In accordance with the Rockcliffe Park Heritage Conservation District Plan Bylaw No. 2016-89 and Part V of the *Ontario Heritage Act* The Rockcliffe Park Residents Association Heritage Committee does not support the proposed development application for 480 Cloverdale.

The proposed changes from the last submission are minor and are insufficient for the design to be compliant with the Rockcliffe Park Heritage Conservation District Plan (RP HCDP), the Rockcliffe Park Secondary Plan (RPSP), Provincial Policy Statement (PPS) and the Standards and Guidelines for the Conservation of Historic Places in Canada (S&G).

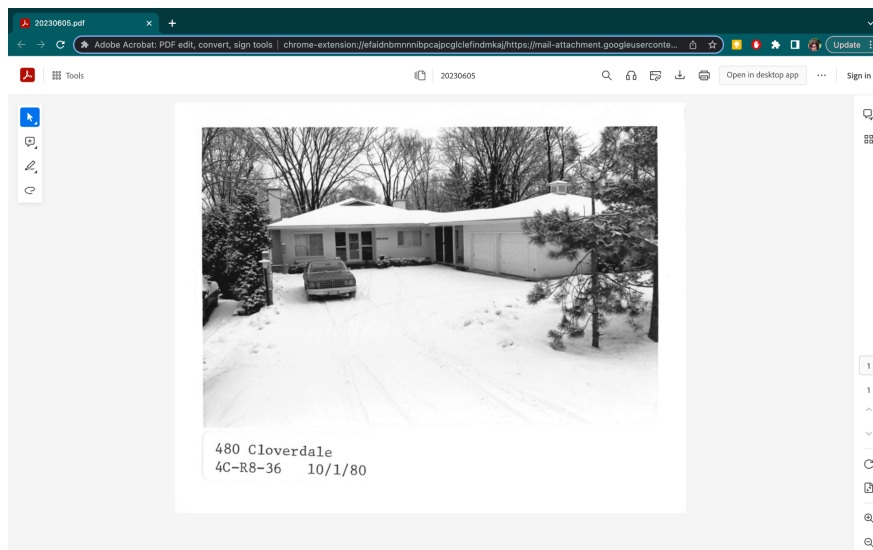
Response: One of the defining features of this lot is the topography which cascades down from the road towards the tennis courts. The length of the proposed design excessively disturbs the existing topography by placing a massive structure that does not follow the downward flow of the hill but instead clashes with the topography by obscuring it.

The previous house on the 480 Cloverdale lot was a bungalow which was smaller in scale, height and mass and was nestled among the trees. (see below) The proposed design is not unobtrusive. The cascading topography is lost by the extending mass of the proposed house.

Ottawa Citizen article Oct 4, 2002

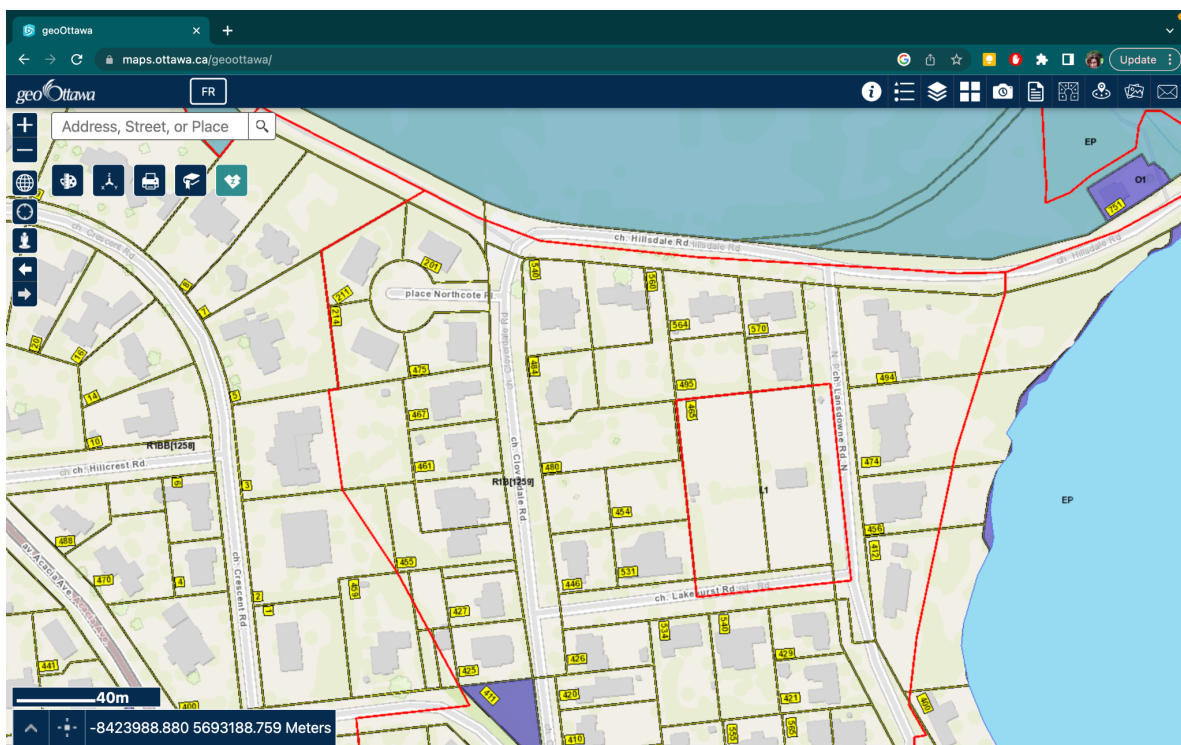
Response: The photo above and Ottawa Citizen newspaper article below indicate there was a bungalow on this property previously, which did not extend as far back as the proposed design. The bungalow was not substantial in mass like the proposed design since it was a single storey structure and had a smaller more compact footprint as opposed to the two storey structure at the front and the three storey structure being considered.
